Hi-Fi Products
Service Bulletin

Model: CDP-C20/C30/C40/C50/C50M/C70/C7ESD

No. 78

Subject: Part Number Missing - Disc Table Frame

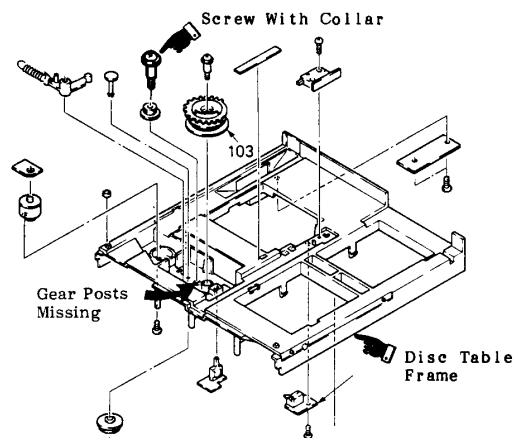
The part number for the Disc Table Frame, shown in the diagram below, is not referenced in the service manual.

The new frame is missing one of the gear posts. A self-tapping screw with collar must be installed as shown in diagram.

Please include this part number in your service manual.

Description	Part Number
Disc Table Frame	4-924-407-06
Screw With Collar	4-926-320-01
